# CITY OF ALBUQUERQUE

**RE: Signal Self Storage & Retail Development  
6221 Signal Ave. NE  
Conceptual Grading and Drainage Plan  
Engineer's Stamp Date: No Stamp Date  
Hydrology File: C18D087**

Based upon the information provided in your submittal received 11/06/2019, the Conceptual Grading and Drainage Plan **is not** approved for action by the DRB on Site Plan for Building Permit and Site Plan for Subdivision. The following comments need to be addressed for approval of the above referenced project:

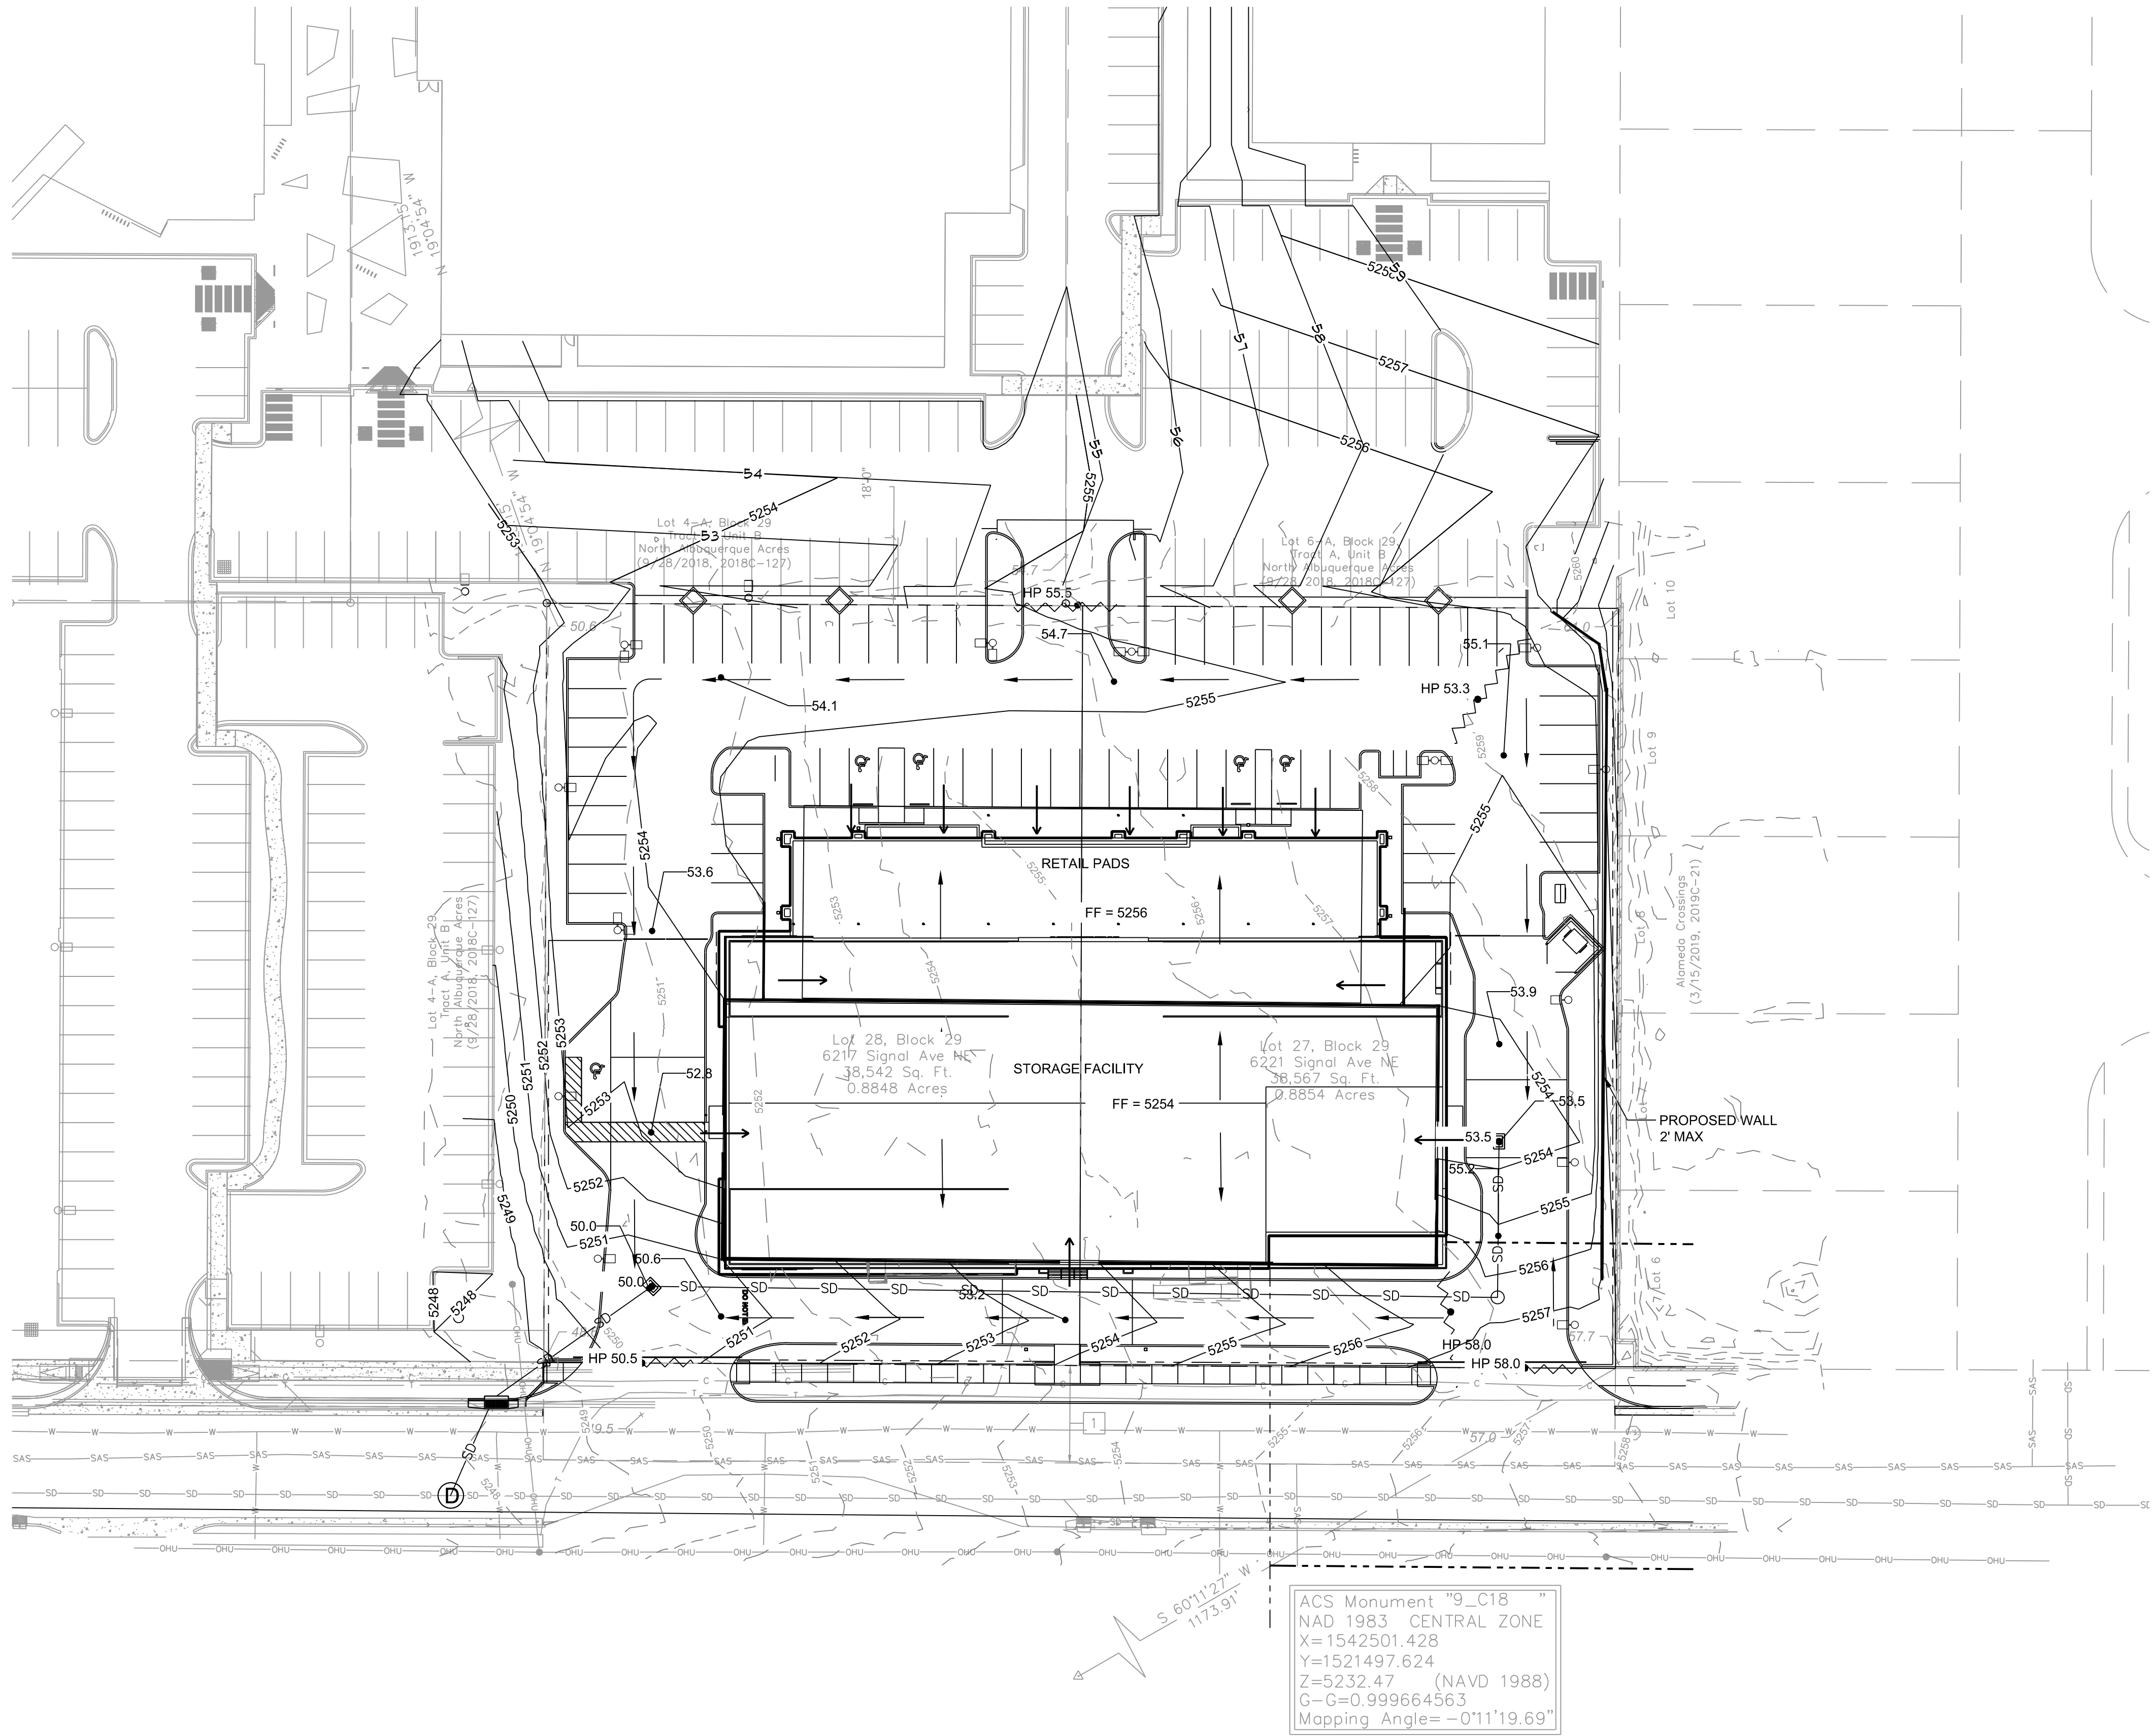
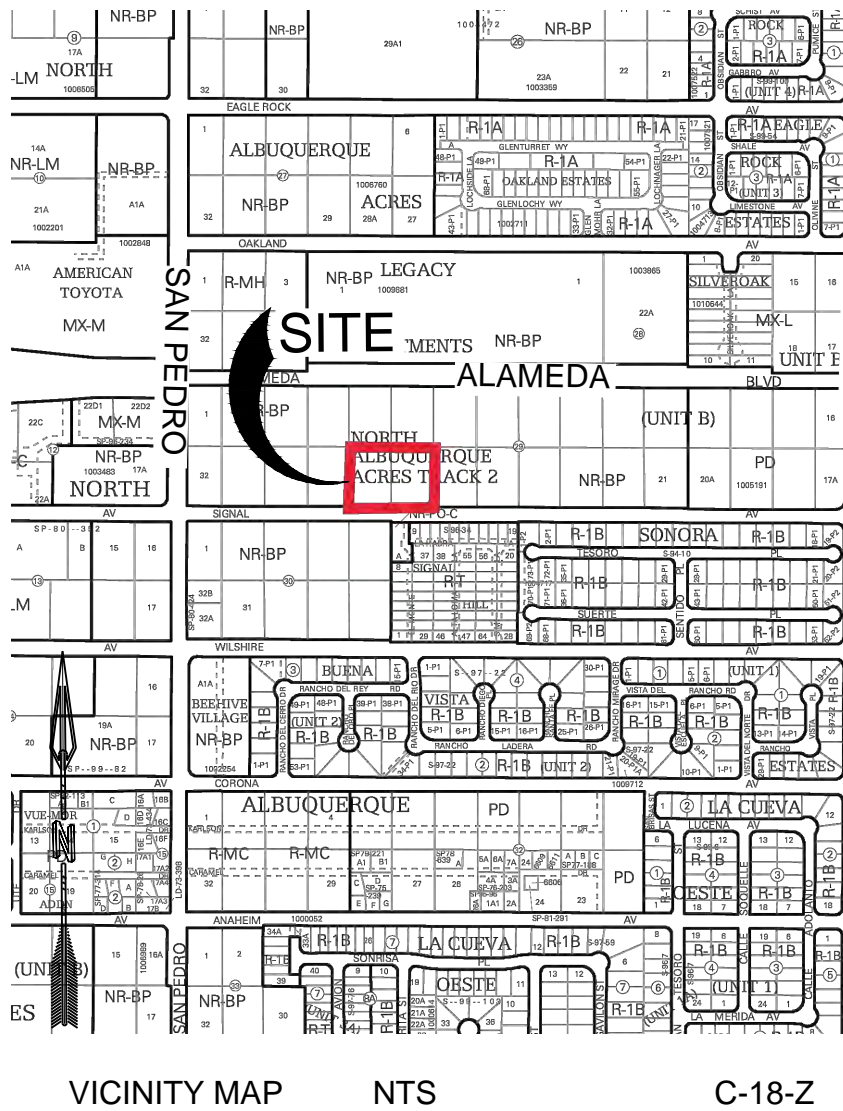
6. Sheet C-200. Please label the proposed drop inlets as Inlet #1 and Inlet #2 with Top of Grate Elevation and Flow Line.
7. Sheet C-200. If the 100 year WSE is above the Top of Grate Elevations, then please show the ponding limits.

8. Sheet C-200. The Proposed Inlet on Signal Ave. is not needed. There is already an existing Type A Inlet that the Pulte Development installed and the downstream Inlet that the Stone Age Climbing Gym (HydroTrans No. C18D086A) installed a Type C Inlet which was sized to handle the runoff within Signal Ave starting from that upstream existing Type A Inlet.

9. Sheet C-200. Provide sections through all external boundaries showing proposed retaining walls, garden walls, property/ROW lines, existing and proposed grades. In accordance with DPM Ch.22, section 5 part B, grading and wall construction near the property line may not endanger adjacent property or constrain its use.

10. Sheet C-200. Please indicate that the revised grading on the adjacent property will be done under a Revised Grading & Drainage Plan for Stone Age Climbing Gym (HydroTrans No. C18D086A). Please then resubmit this Revised Grading & Drainage Plan prior to Building Permit approval for this project.

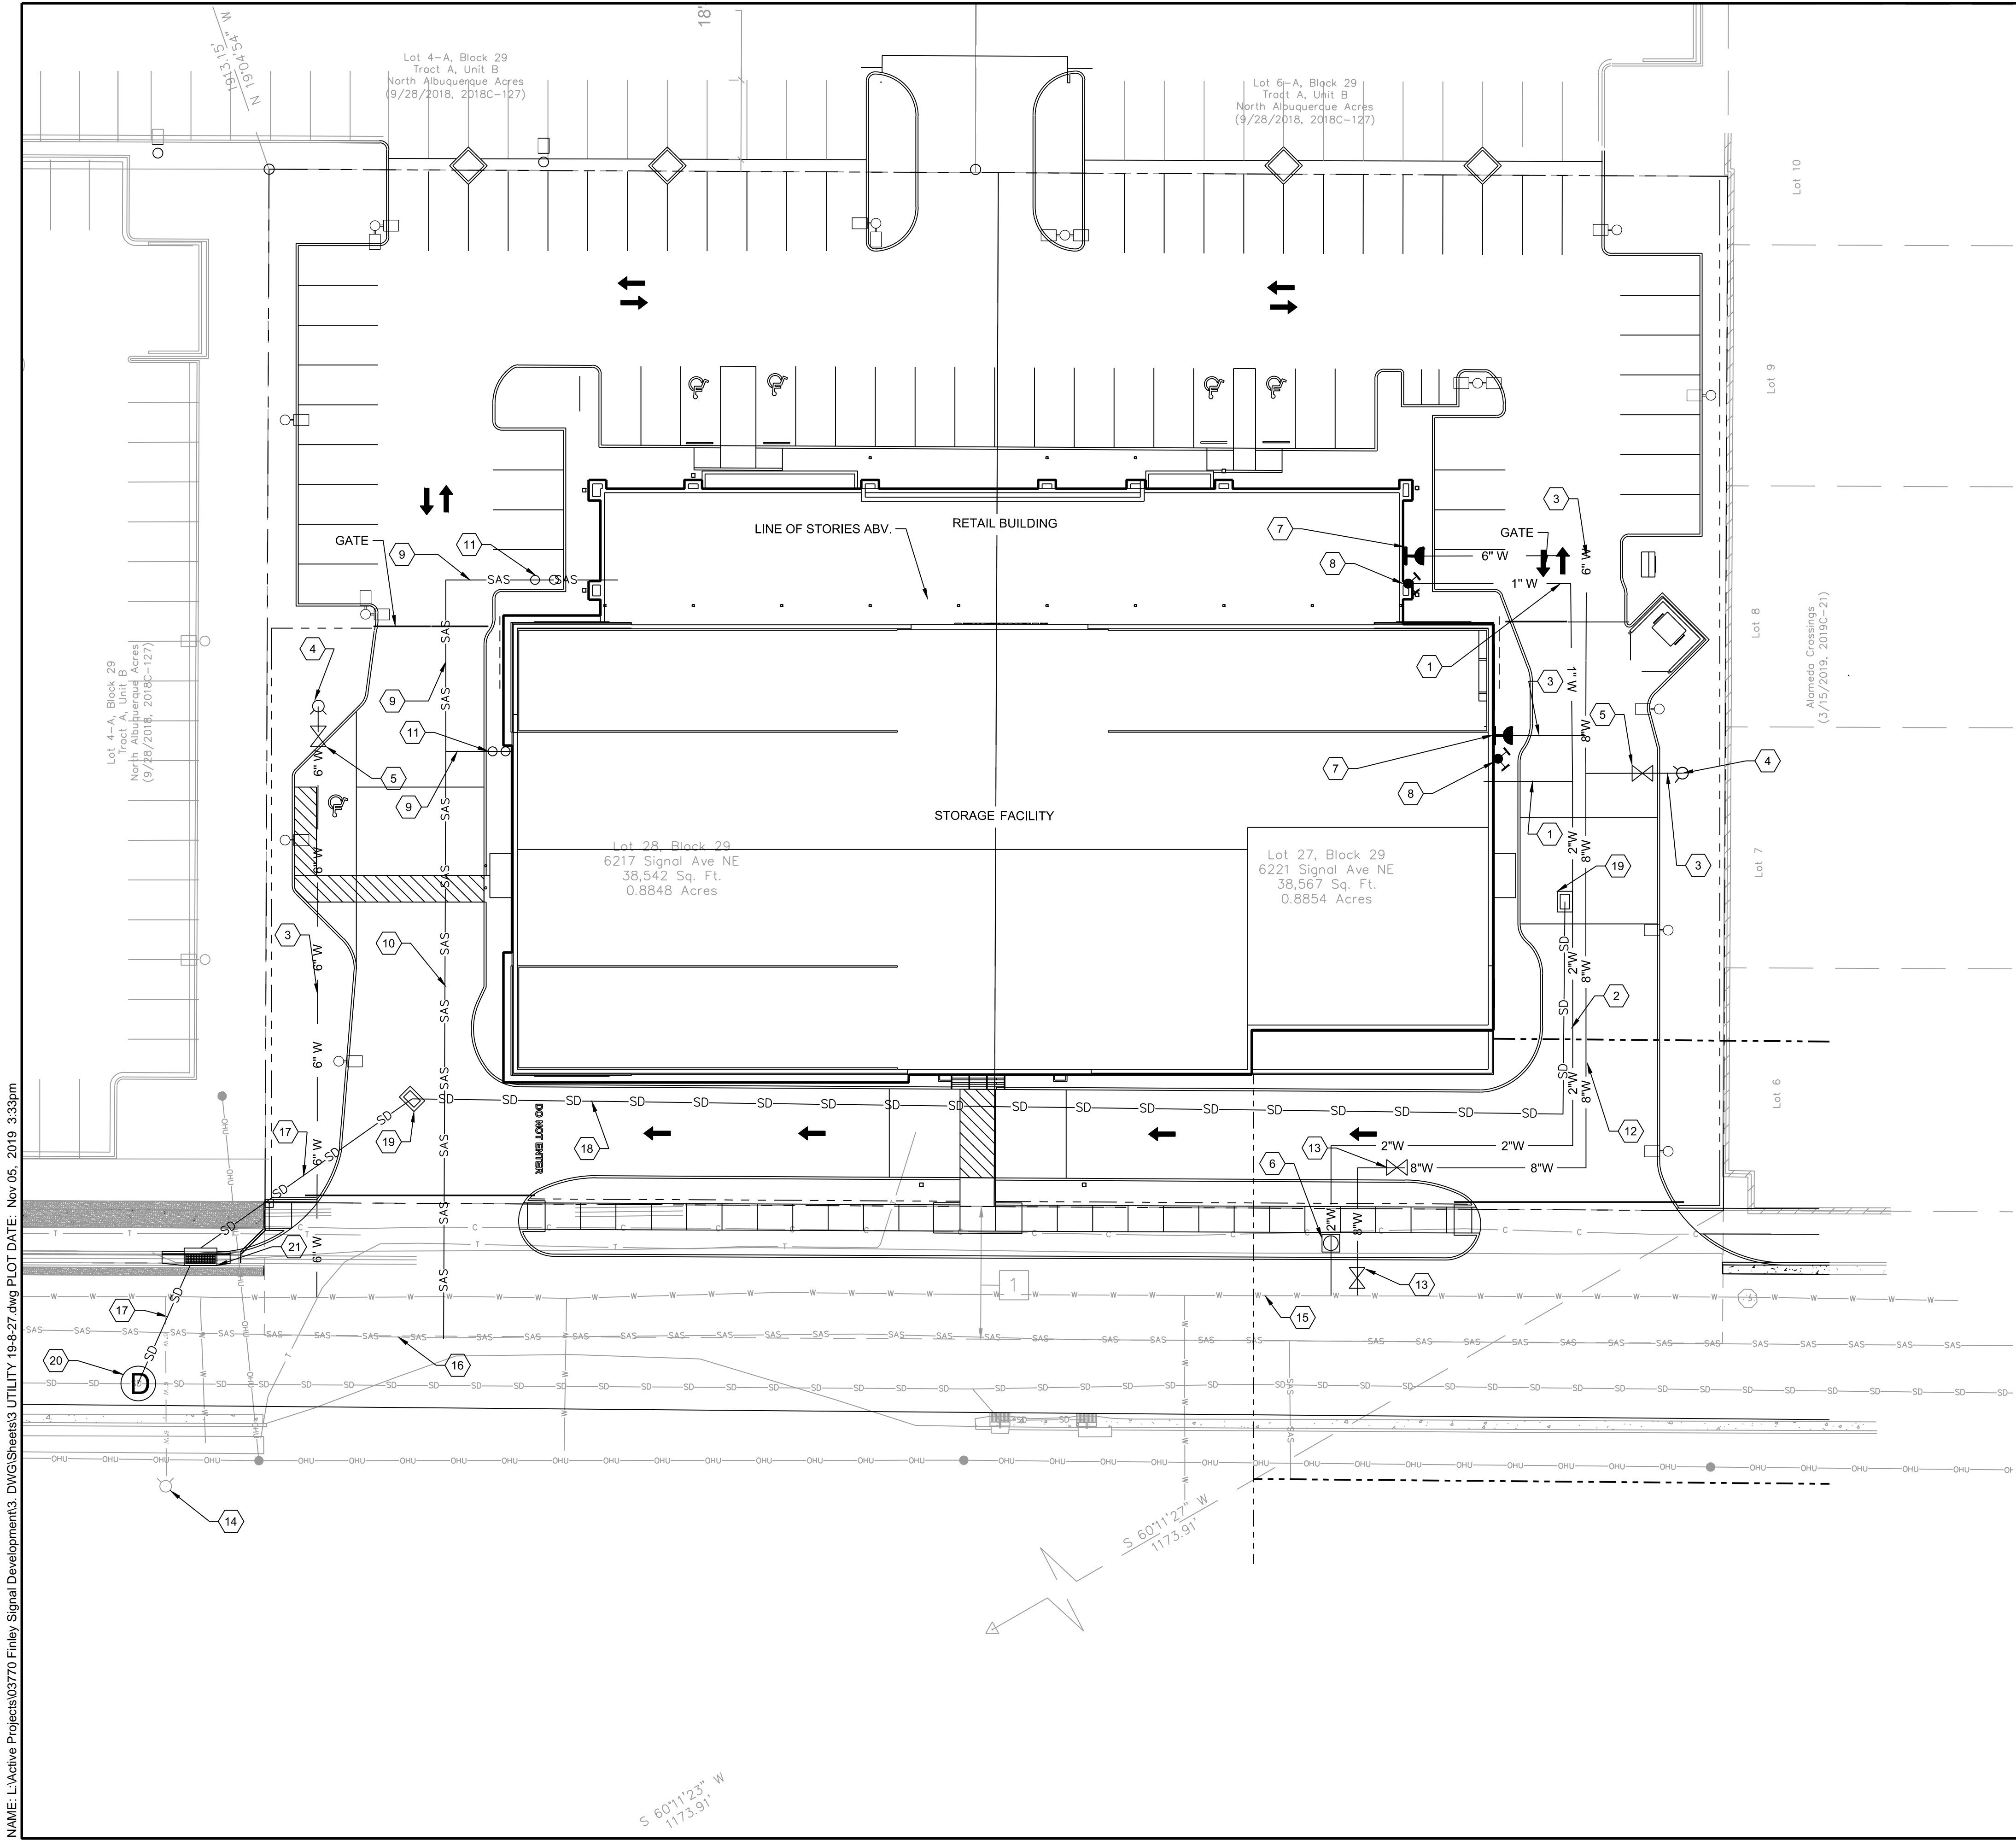
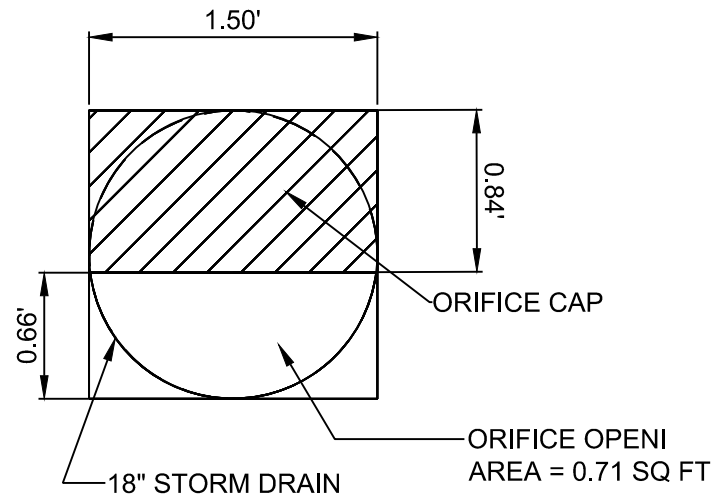
1. Please provide an engineer's stamp with a signature and date on all sheets.
2. Please add a note, "Not for Construction" on all sheets.
3. Sheet C-100. Please revise the existing conditions and all references to the Master Drainage Plan. This site is within the North Albuquerque Acres Master Drainage Plan only. This site was not part of the analysis report "Alameda Blvd San Pedro to Wyoming Project #7663.91 by Thompson Engineering dated January 2012. The NAAMDP has this site with an allowable discharge rate of 3.82 cfs/ac. Therefore the allowable discharge for the 1.77 ac site is 6.76 cfs.

4. Sheet C-100. Please include the orifice equation for the orifice plate.
5. Sheet C-100. Please label / indicate where the orifice plate is to be installed.
